Detailed Site Plan

DSP-18046

Application	General Data	
Project Name: Burger King #1155 Location: On the south side of Bladensburg Road and on the north side of Newark Road, at the intersection with 40th Avenue. Applicant/Address: Carrols, LLC 968 James Street Syracuse, NY 13203	Planning Board Hearing Date:	04/25/19
	Staff Report Date:	04/04/19
	Date Accepted:	02/11/19
	Planning Board Action Limit:	07/02/19
	Plan Acreage:	1.639
	Zone:	M-X-T/D-D-O
	Dwelling Units:	N/A
	Gross Floor Area:	3,276 sq. ft.
	Planning Area:	68
	Council District:	05
	Election District:	02
	Municipality:	Colmar Manor
200-Scale Base Map:	205NE03

SUBJECT: Detailed Site Plan DSP-18046
Burger King #1155

DETAILED SITE PLAN

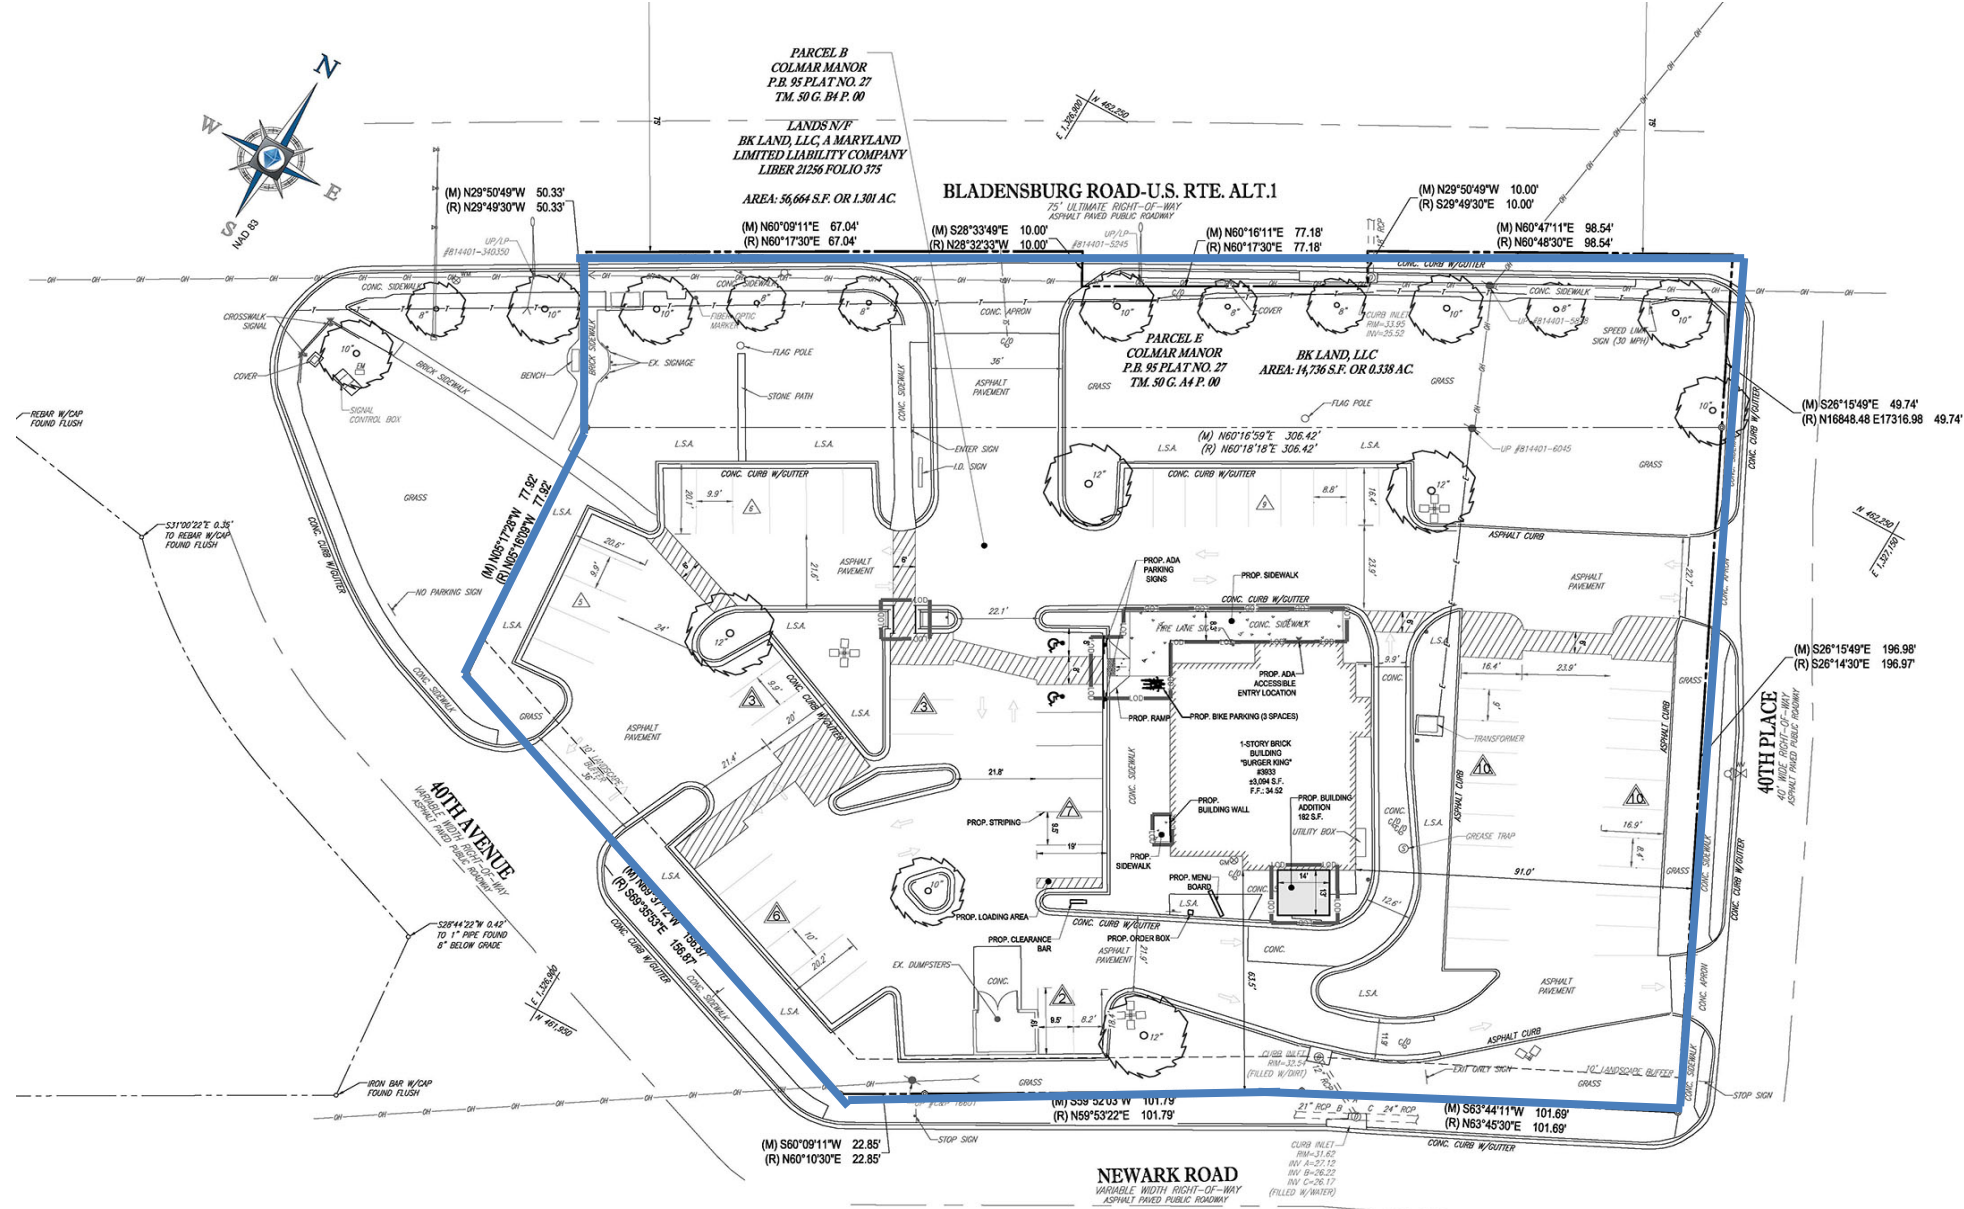
- f. Remove the “proposed loading area” label from the site plan.
 - g. Show all sidewalk widths and building dimensions on the site plan.
 - h. Show one continuous pedestrian connection from the sidewalk, within each adjacent public right-of-way, to the sidewalks adjacent to the building.

10. My manual parking count from sheet 4 of the DSP (68) doesn't match the "Total Proposed" count in the parking schedule on the Cover Sheet (63).
11. Some drive isle widths are not provided and some are provided and too narrow, like the single direction drive isle exiting the drive thru, which is only 9' and the two-direction drive isles in some of the parking lots, which are under 22'. All one direction drive isles must be a minimum of 11' wide and all two direction drive isles must be 22' wide.

12. Show ALL sidewalk widths and building dimensions on the Site Plan.
13. Compact Parking callouts on the site plan should be shown and differ from callouts for Standard Spaces.

SIGNAGE

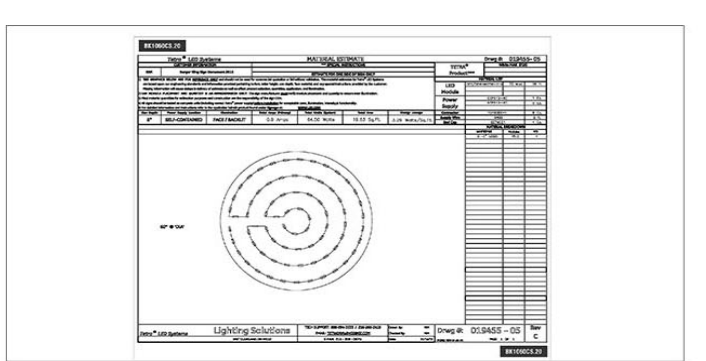
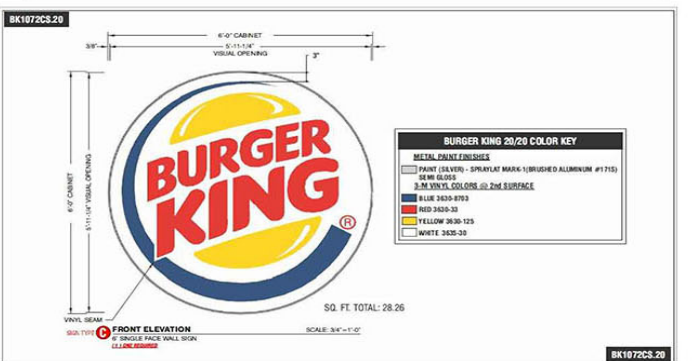
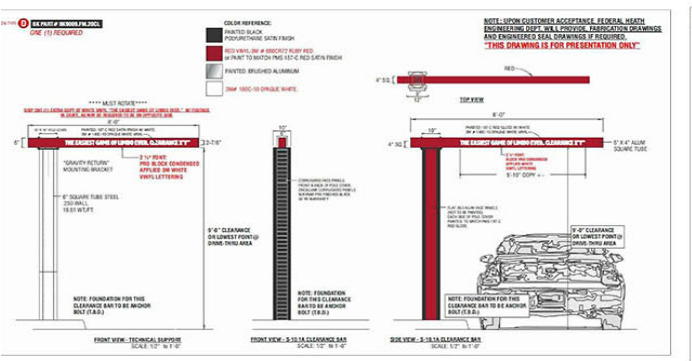
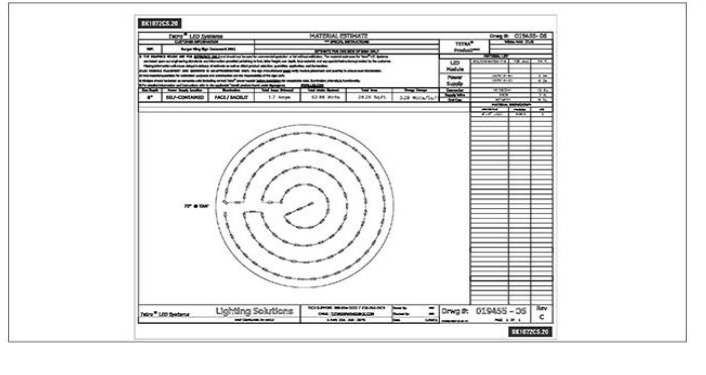
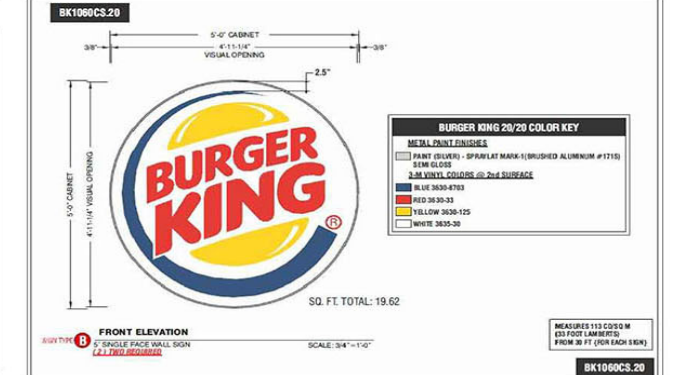
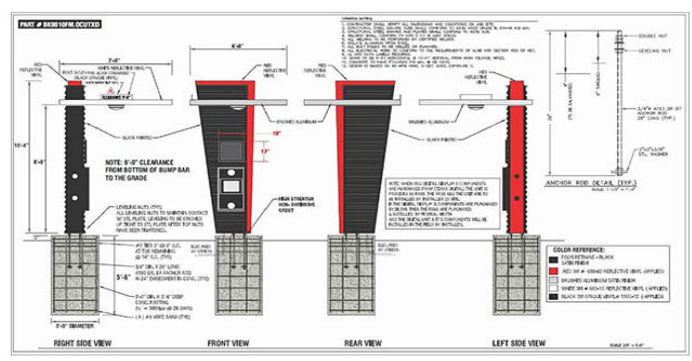
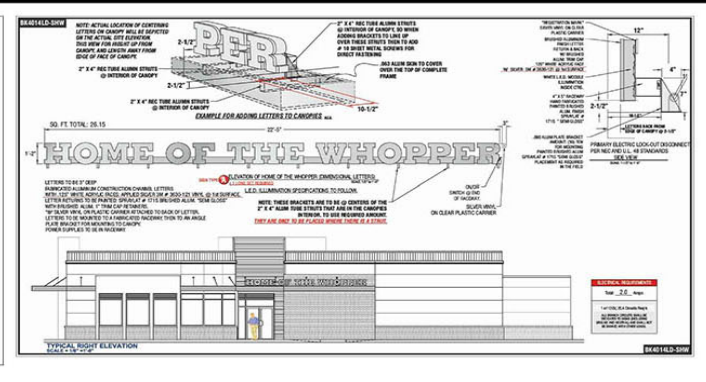
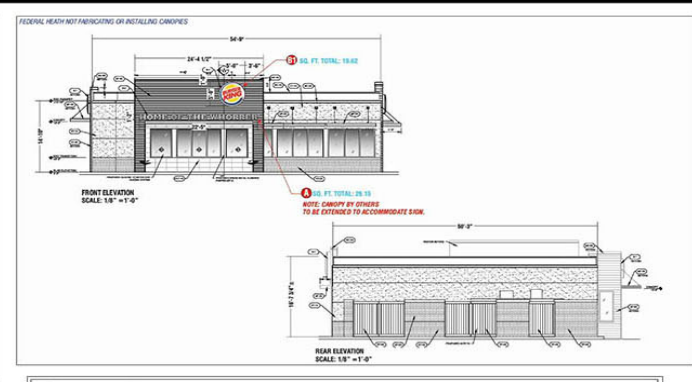
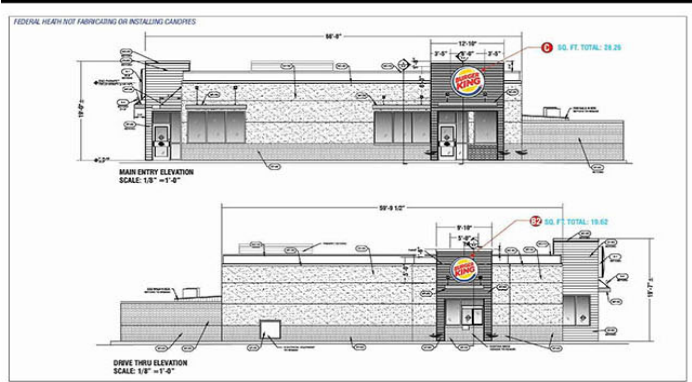
- d. On Sheet 7 of the DSP, identify the specific sign detail for each box (e.g., Menu Board Detail, Clearance Bar Detail, Canopy Sign Detail, etc.).
 - e. Label the compact parking spaces on the site plan.

5. In reference to No. 3, above, the details for the signs on sheet 7 of the DSP also need to be corrected to match.

6. Aerial imagery and the DSP show a free-standing/ID sign at the entrance, which is not shown in the sign details. Show all signs and provide details.

7. Under each square containing sign details on sheet 7 of the DSP there should be a label stating what the detail is for (e.g., Menu Board Detail, Clearance Bar Detail, Canopy Sign Detail, etc., etc.).
